User Safety Notice

50 ft. / 15 m. Workman® Self-Retracting Lanyard

October 28, 2015

Yellow Tamper Evident Paint

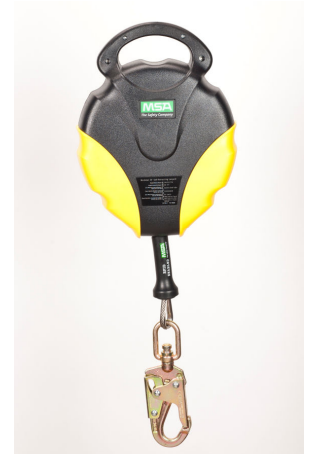
Please note that the replacement SRLs may also have a “date made” from 01-2015 through 08-2015, but include yellow tamper evident paint on the exterior housing screw heads near the handle, as shown in the photo below. These SRLs are new units that were factory upgraded to include a new brake assembly and are acceptable for use.
